City of **HOBART**

APPLICATION UNDER SULLIVANS COVE PLANNING SCHEME 1997

Type of Report: Committee
Council: 29 October 2018
Expiry Date: 7 December 2018
Application No: PLN-18-505
Address: 10 EVANS STREET , HOBART
6 EVANS STREET , HOBART
ADJACENT ROAD RESERVE
Applicant: Alicia Mora (Macquarie Point Development Corporation C/- Veris)
PO Box 5075
Proposal: Cycleway Extension and Associated Works
Representations: Four (4)
Performance criteria: Heritage, Archaeology, Use

Figure 2: The proposed landscaping plan for the cycleway provides a comprehensive overview of the location and scope of works proposed.

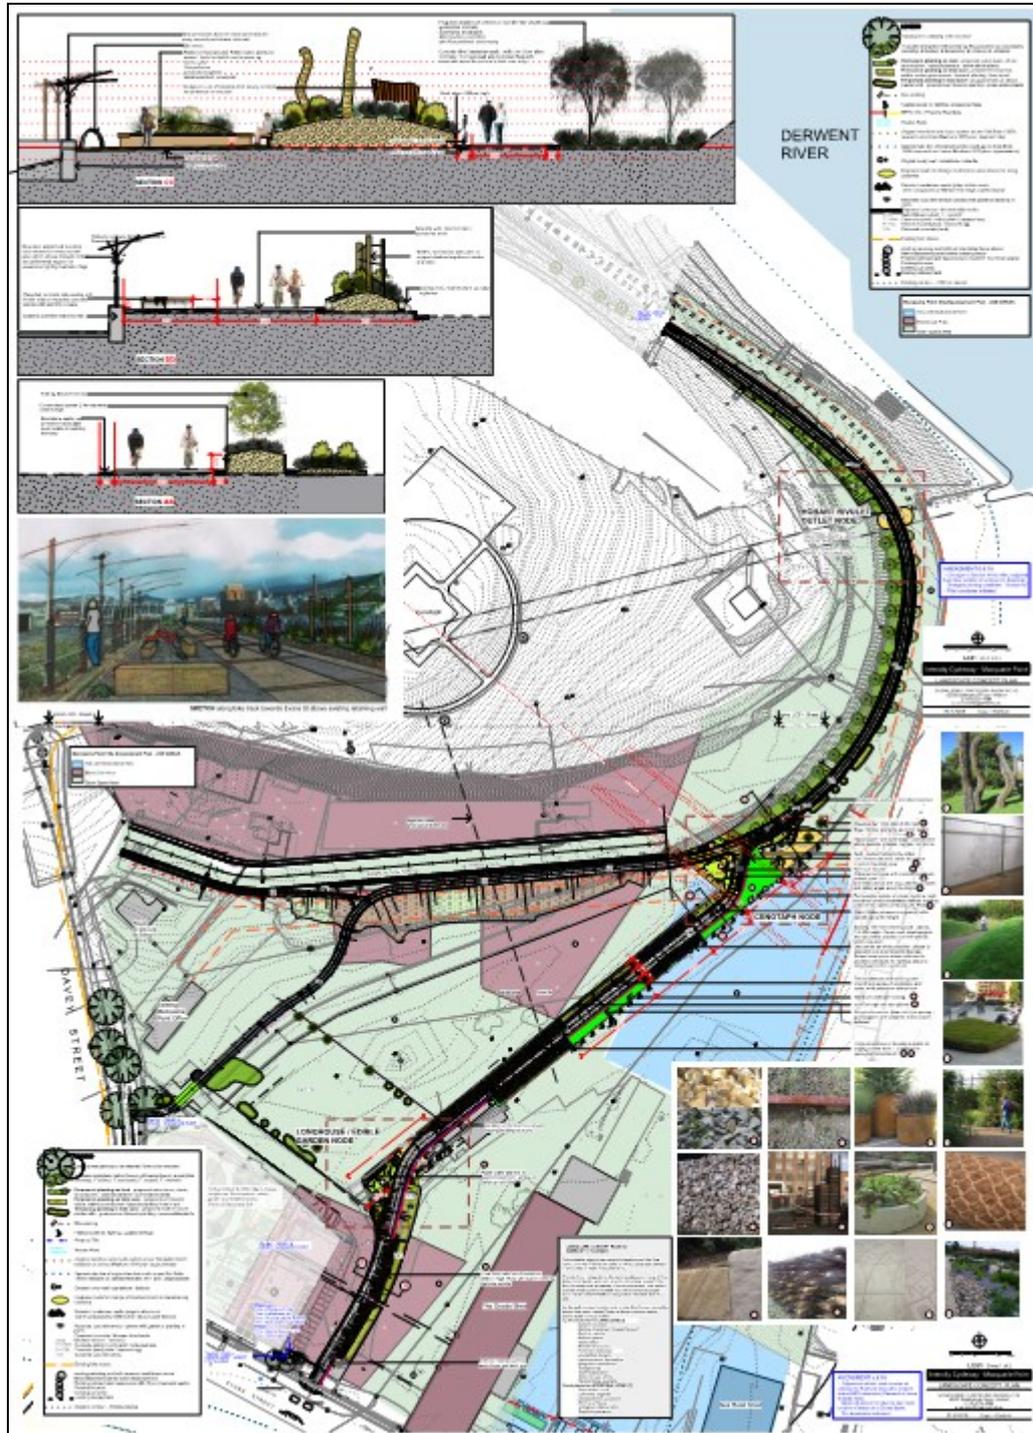
One representor has indicated that appropriate consultation with TasRail has occurred and that the requirements for a setback to the rail corridor have been adequately considered.
Two representors have indicated support for the extension to the cycleway and the pathways chosen to undertake this.
Representors have indicated desire for specifications of the locations and constructions of all junctions with roads to ensure the safety of users and to minimise the risk of conflict with larger vehicles.
Representors have commended the dimension of the central road refuges proposed, indicating that they are adequate to accommodate cyclists safely.
One representor has indicated that the proposed planters and seats along the cycleway need to be provided minimum setbacks from the pavement of the cycleway to ensure that they do not pose hazards or risk users of the seating being hit by bicycles if there is not sufficient clearance for their legs.

One representor is concerned that the proposed cycleway may impede the construction and operation of a future light rail link to the northern suburbs. The representor has indicated that there was not sufficient information submitted with the application for them to assess whether the cycleway is proposed along the old rail line, or if it is near the old rail line.
One representor is concerned that there is a missing link between the existing cycleway and the proposed new cycleway. They have indicated that there is a section of publicly owned land which does not have a formal cycleway to connect to the proposed, and that the only logical place for the construction of this link is along the old rail corridor. They have raised objection to this possible future alignment.
One representor has requested that the cycleway be redesigned to ensure that it does not impede the possible future rail network.

6.9.4 The proposed works are essentially paving and landscaping to enable safe use of the site by cyclists. As such it will have no built form, and will not impact on the use of the surrounding area in any way. Cyclists will be directed to safer crossing points for the Evans Street crossing, which will improve safety for all users. One entrance to the site, and the main landscaped corridor are located such that they will reinforce the Goods Shed as the primary entrance to the site.

Figure 3: The red highlighted areas are of archaeological sensitivity. Number 12 is located within the Macquarie Point site, and the cycleway will encroach into it.

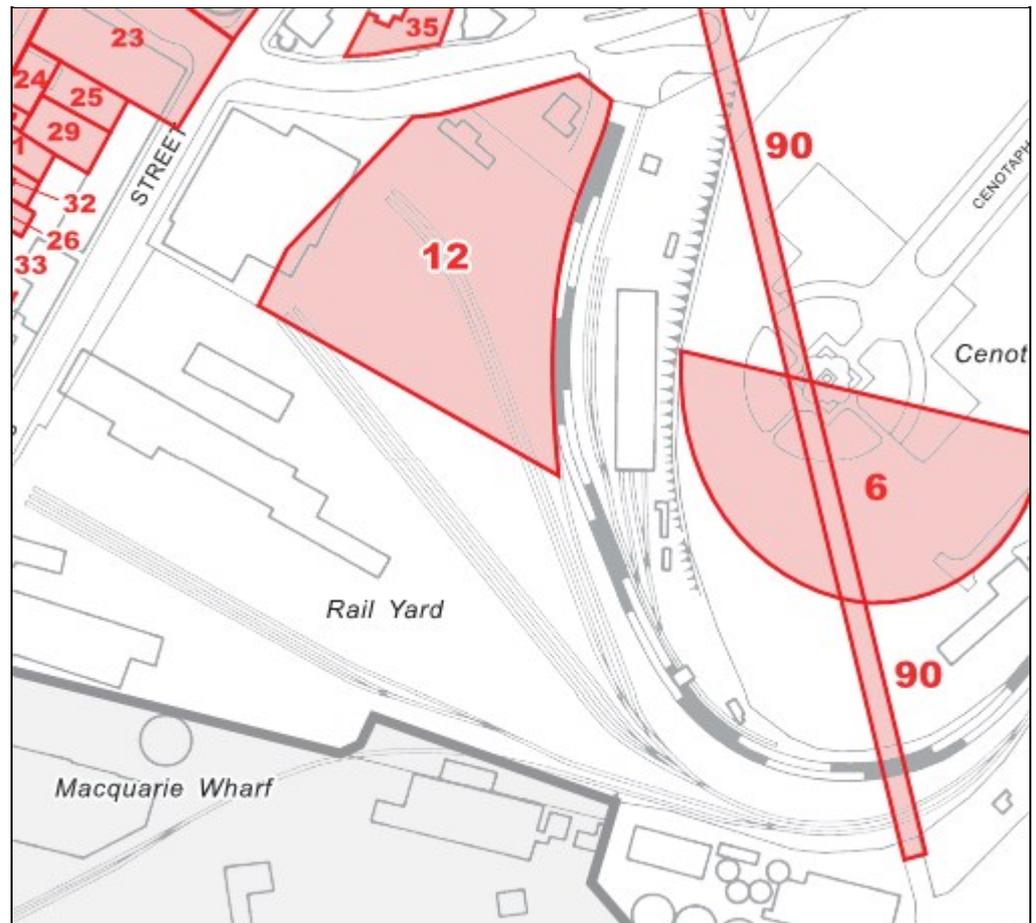
1. Excavations within place No. 12 of the Scheme are unlikely to result in the destruction of items of archaeological significance. No excavations are proposed for the revised area of archaeological sensitivity as defined in the 2015 test excavation report (Figure 2 above). The 2015 report recommended that no further archaeological investigation was required for excavations occurring outside of the revised sensitivity zoning.

2. Excavations within place No. 90 of the Scheme are unlikely to result in the destruction of items of archaeological significance related to the Domain Diversion Tunnel. However, care should also be taken during works to avoid inadvertent impacts to the tunnel.

1. For precautionary purposes and in the Project Specifications it would be prudent to put in place notification protocols whereby archaeological advice is sought in the unlikely event that features or deposits of an archaeological nature (This may include but not be limited to the exposure of orange hand made clay bricks or sandstone blocks forming walls or surfaces, or artefacts such as fragments of ceramic, bottle glass, bone, shell or other items) are uncovered during excavation or where doubt exists concerning the provenance of any strata revealed during excavations. In such instances, excavation should immediately cease pending attendance on site and receipt of advice from a qualified archaeologist, at which point, depending on the findings, it may also be necessary to involve the Hobart City Council in discussions.

Subject to the imposition of an appropriate condition to reflect the requirements of the archaeological report, the proposal is considered satisfactory.

All onsite excavation and disturbance must be monitored. Should any features or deposits of an archaeological nature be discovered on the site during excavation or disturbance:
